FIRST DRAFT MINUTES

March 20, 2014 Standards Committee Meeting

RE: Minutes from the March 20, 2014 Standards Committee Meeting

802-SNGP-01 SIGN PLACEMENT WIDE FLANGE SIGN SUPPORT (REVISED DRAFT)

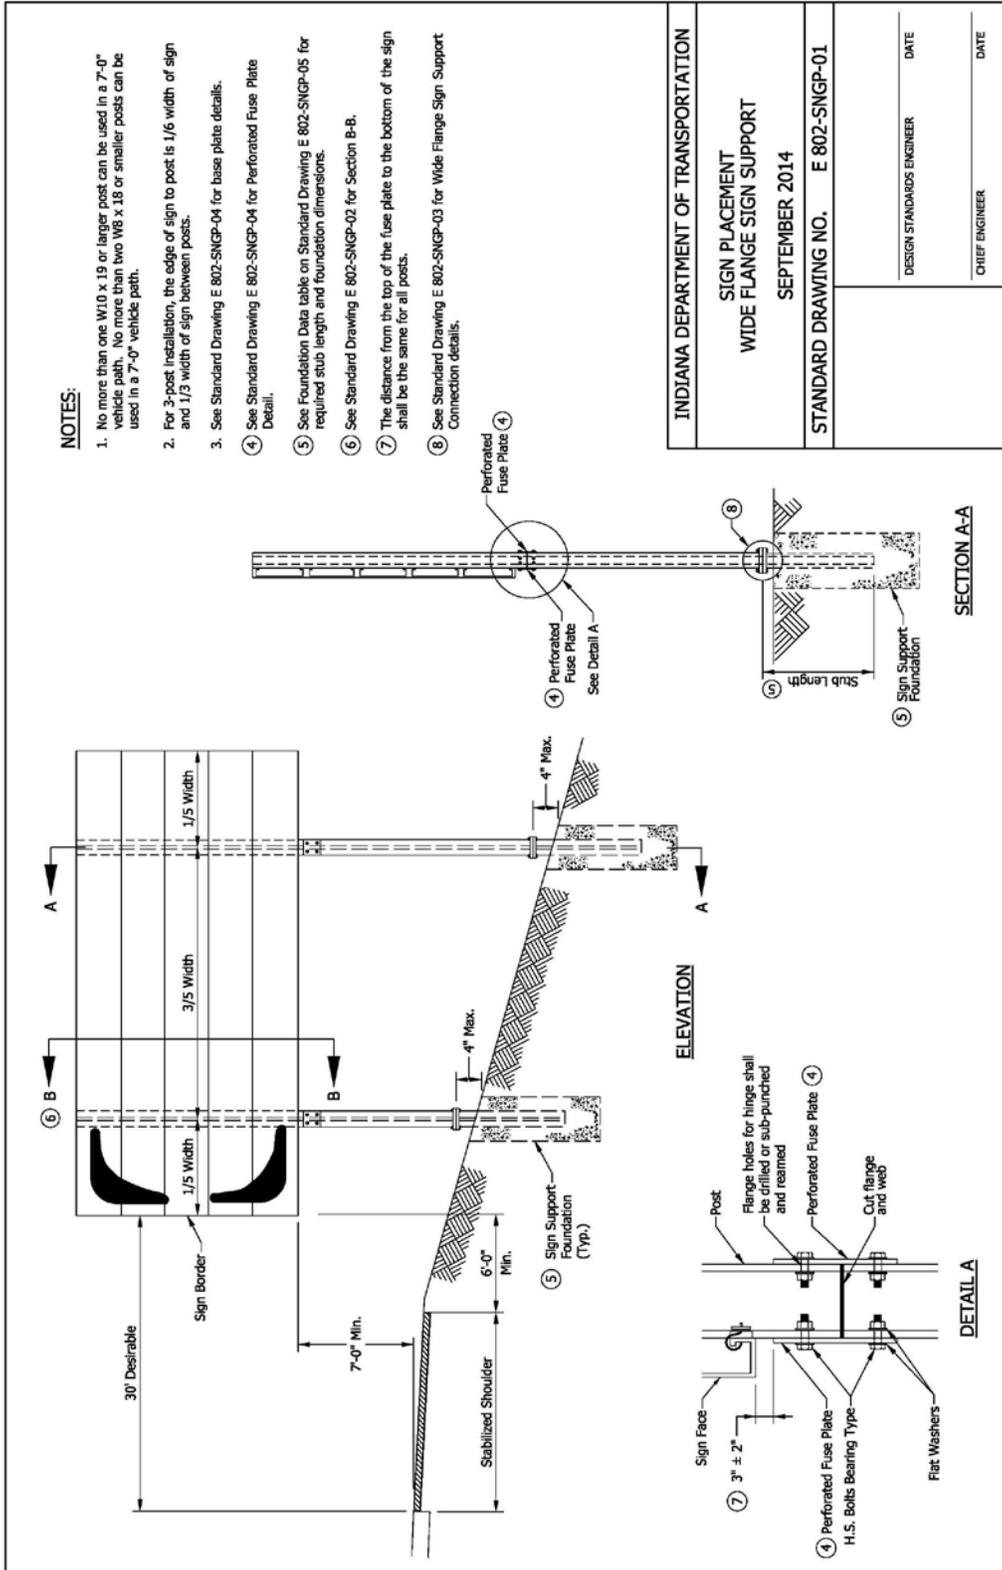
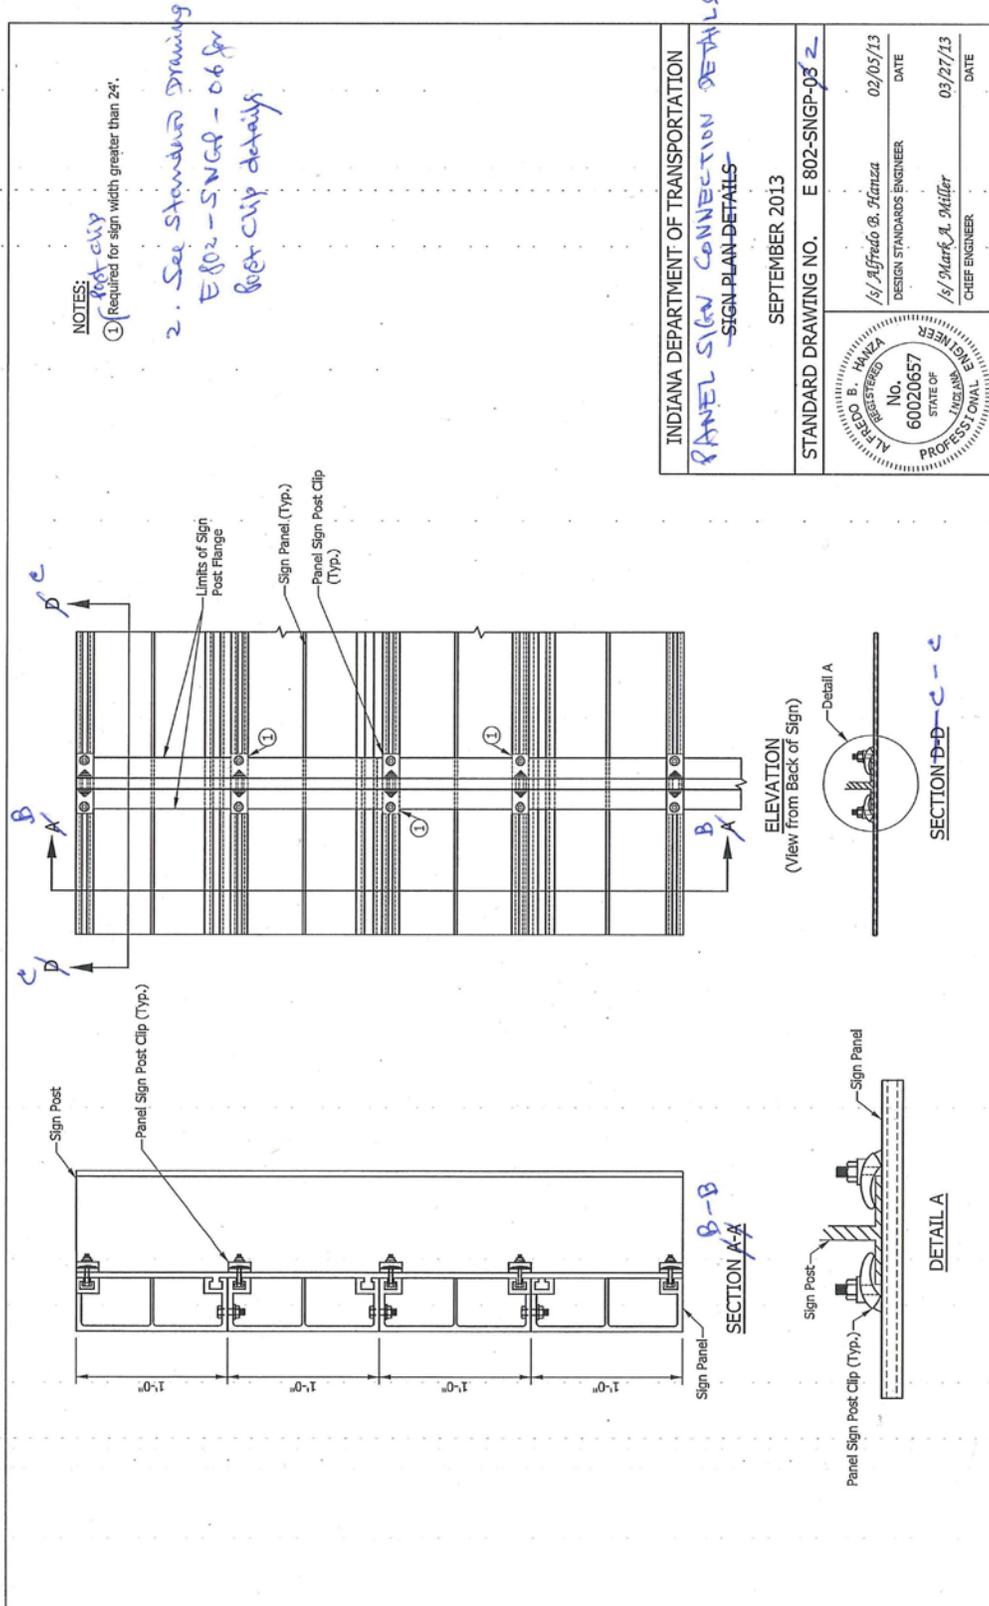
PROBLEM(S) ENCOUNTERED: Standard Drawings 802-SNGP-13 and 802-SNGP-14 showing Sign Placement for divided highway intersections with medians 30 ft or wider do not include the ONE WAY signs in the median that are required by the 2011 IMUTCD.

Mr. Miller asked about note 1 on sheet E 802-SNGP-01, concerning the distance between posts. Mr. Pankow offered clarification that there are to be no more than two posts within 7 ft of each other. Mr. Miller asked if that information should be in the design manual, instead of on the standard drawing, and if designed correctly, that note would not be necessary. Further discussion ensued concerning sign design and layout and placement. Following the discussion, it was determined to leave the note with adding a word "vehicle".

802-SNGP-04 PLATE AND SHIM DETAILS (REVISED DRAFT)

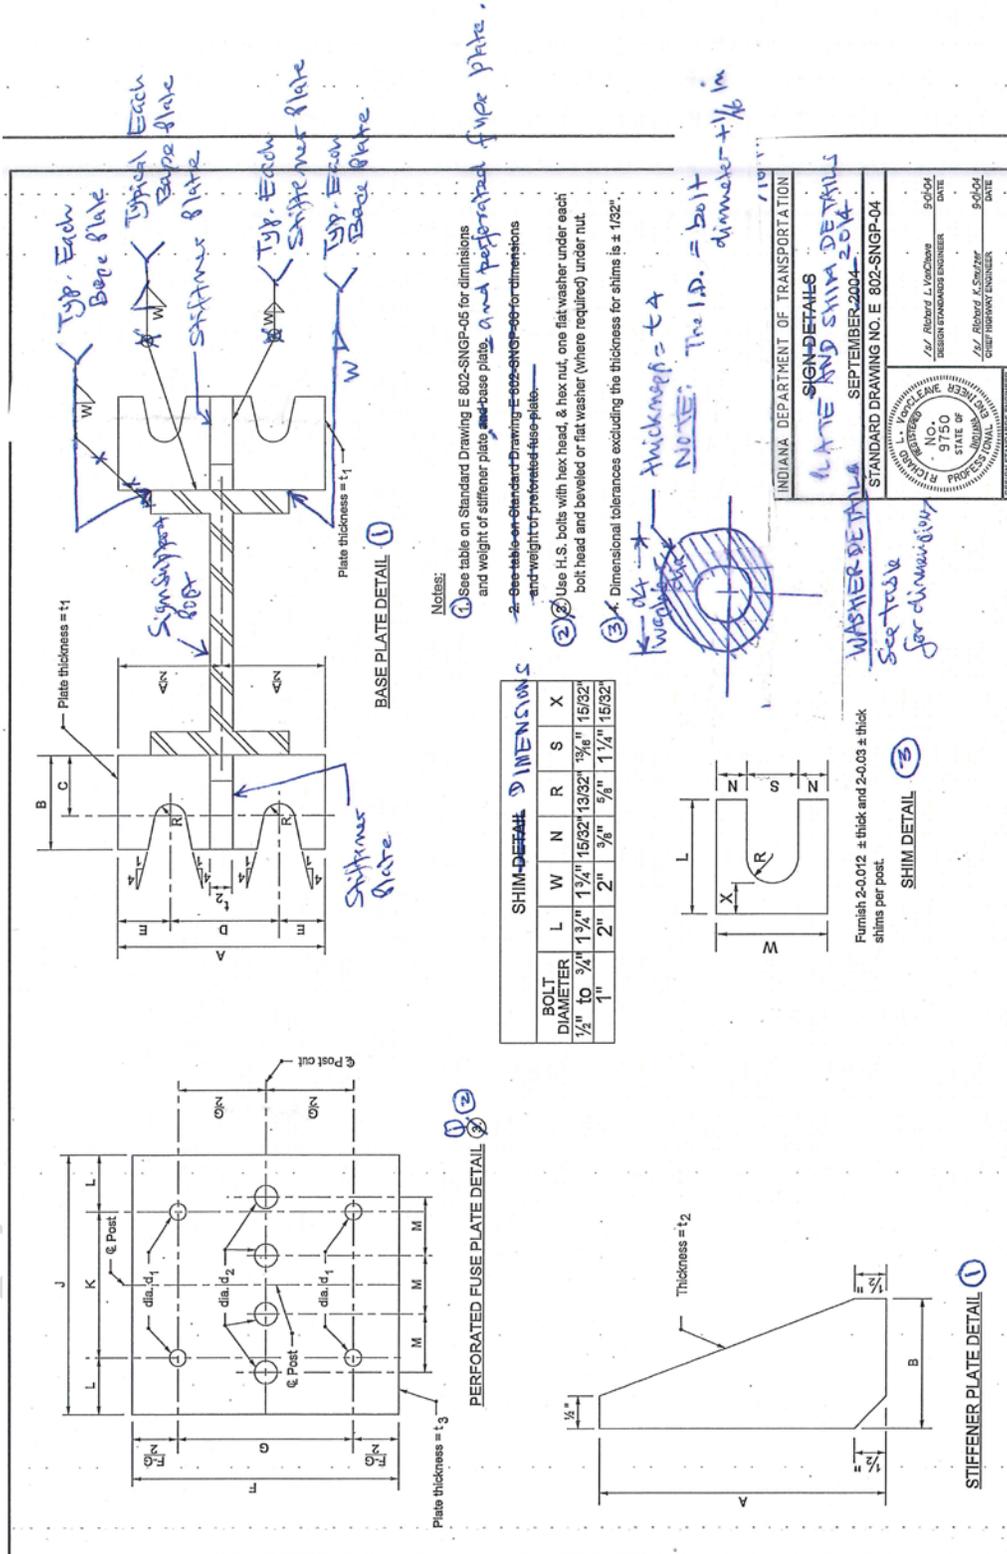
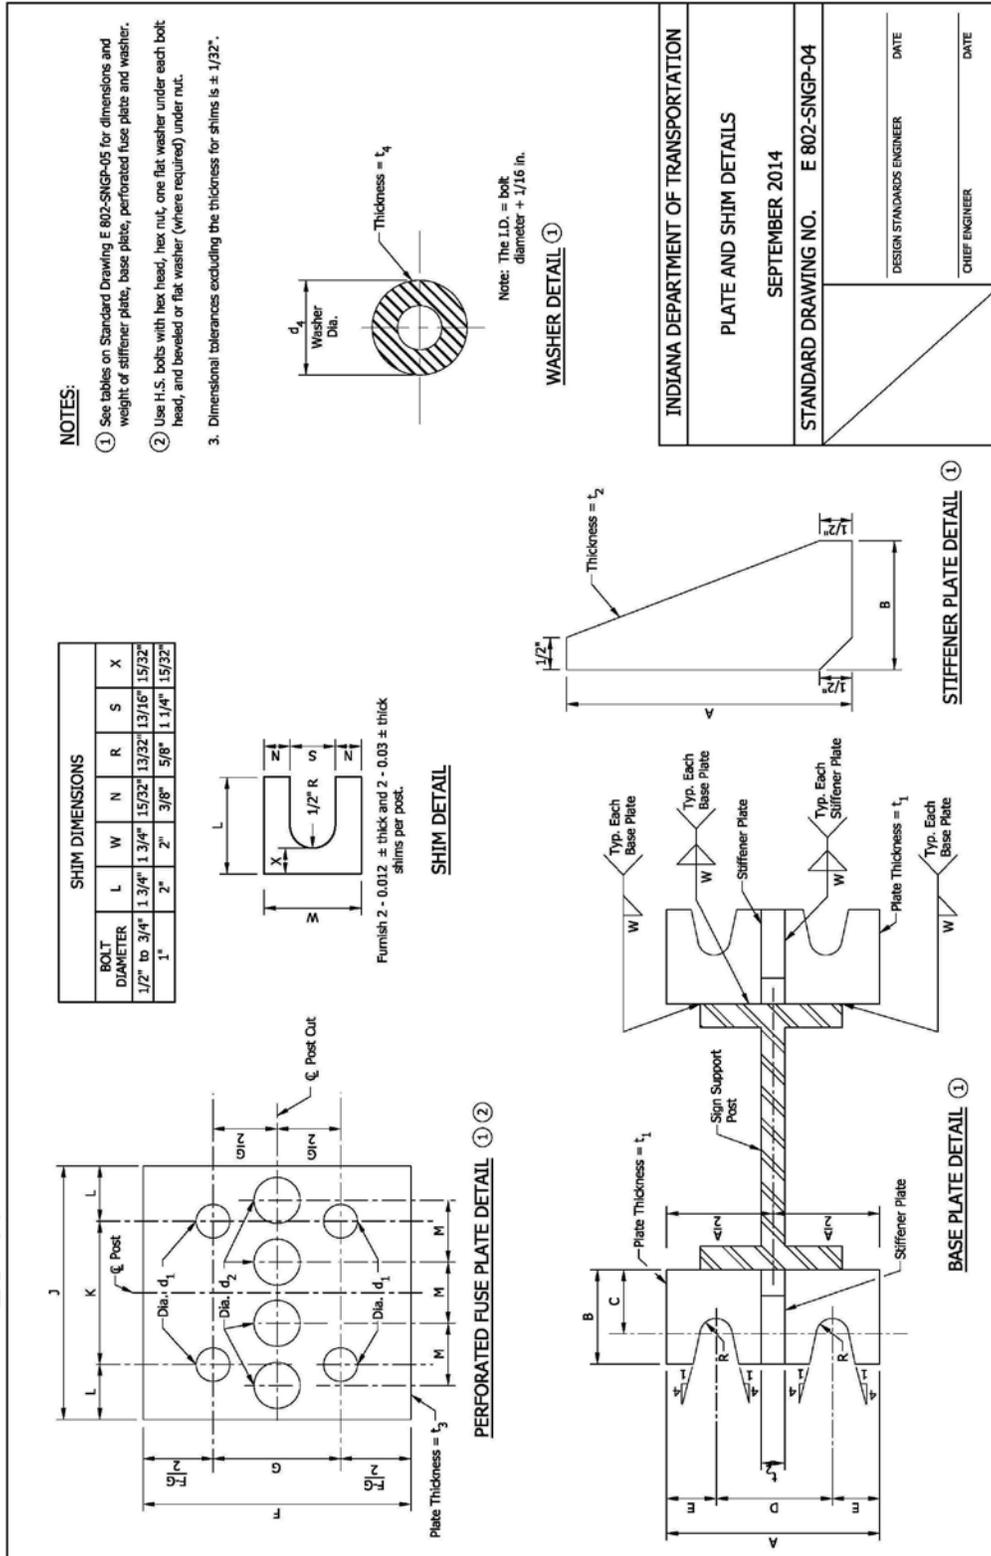
DISCUSSION: This item was introduced and presented by Mr. Boruff who stated the reasoning behind these standard drawing revisions, as shown on the proposal sheet. Mr. Boruff further explained some of the drawing revisions shown. Mr. Garg handed out revised drawings for E 802-SNGP-04 and -05 showing plate and shim details which clarify the washer type and thickness. Also revised is drawing E 802-SNGP-01, which clarifies Note 1 regarding the 7 ft wide vehicle path.

802-SNDH-01 SIGN PLACEMENT DIVIDED HIGHWAY INTERSECTION MEDIAN WIDTH < 30 FT (DRAFT)

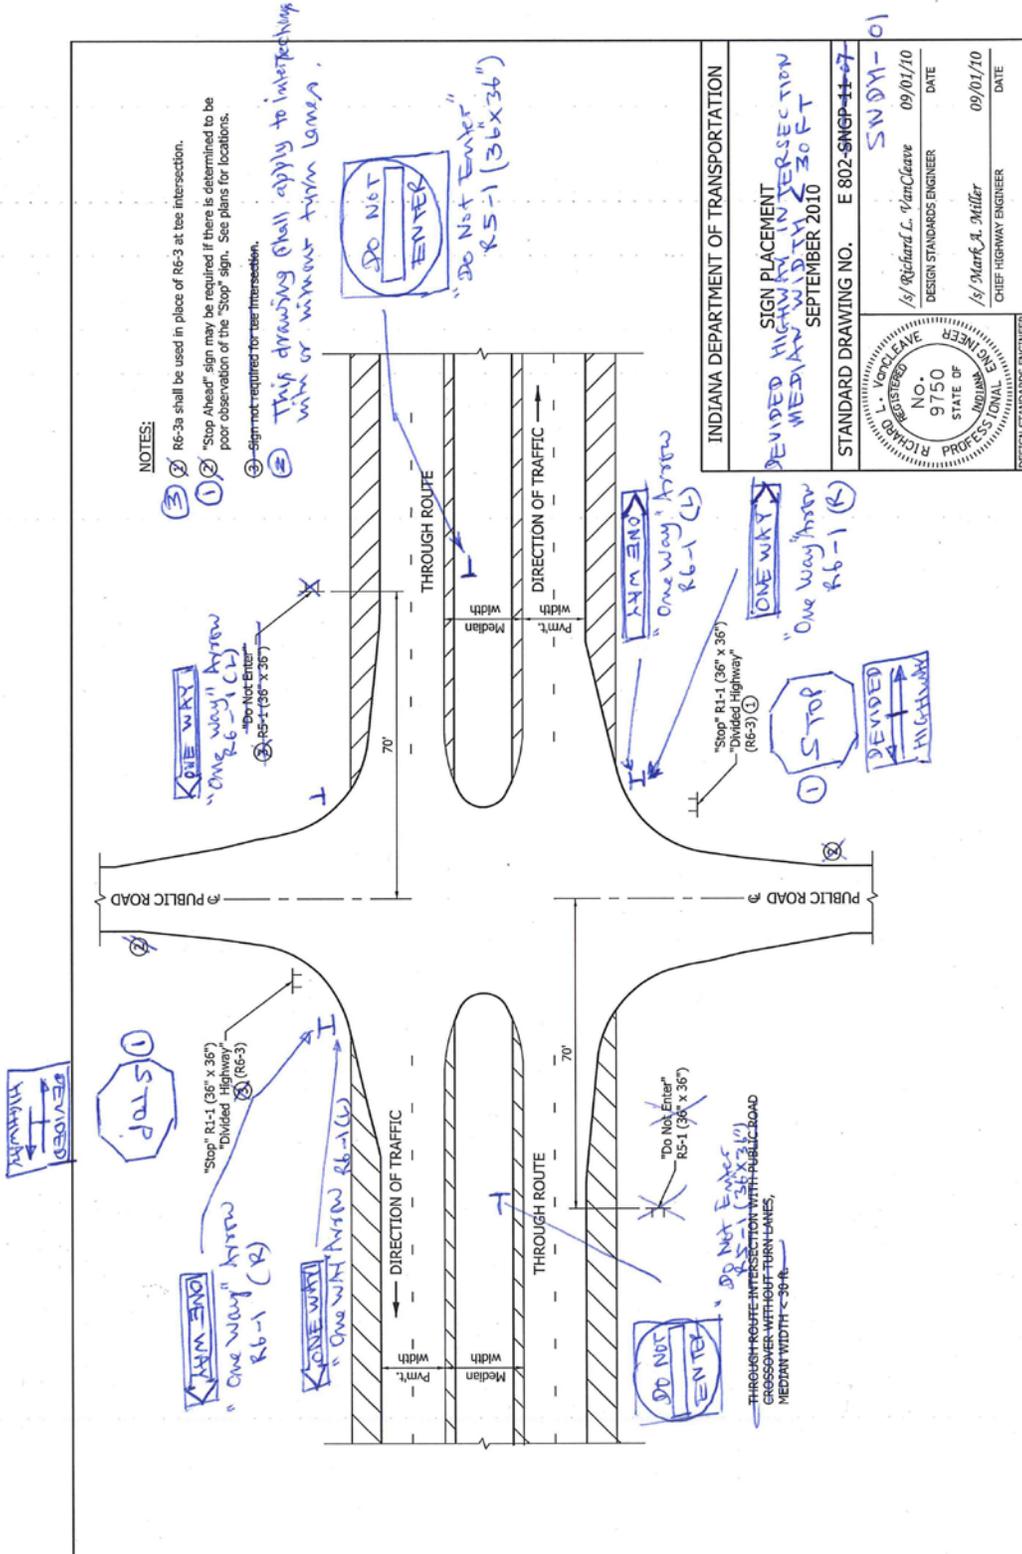
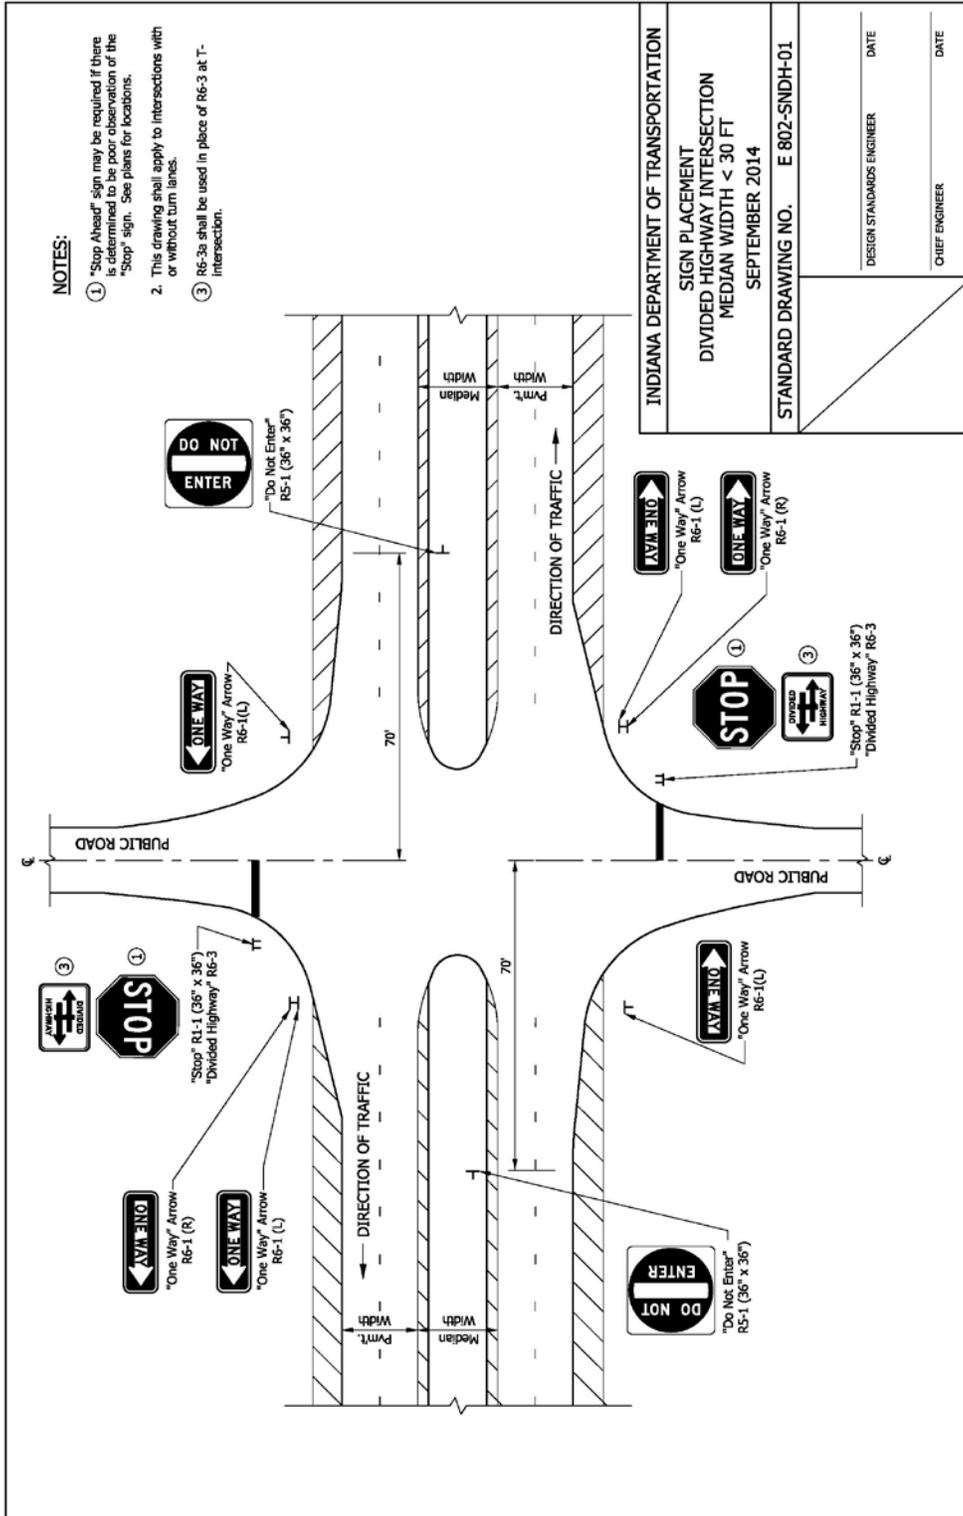
1. 802-SNGP-11 and 802-SNGP-12 show identical signing
2. 802-SNGP-13 and 802-SNGP-14 also show identical signing
3. 802-SNGP-05, 802-SNGP-06, 802-SNGP-07 which show sign post and foundation data can be condensed.

PROPOSED SOLUTION: Revise Standard Drawing 802-SNGP-13 and place in a new series, 802-SNDH. Also move 802-SNGP-11 into the new series and eliminate 802-SNGP-12 and 802-SNGP-14.
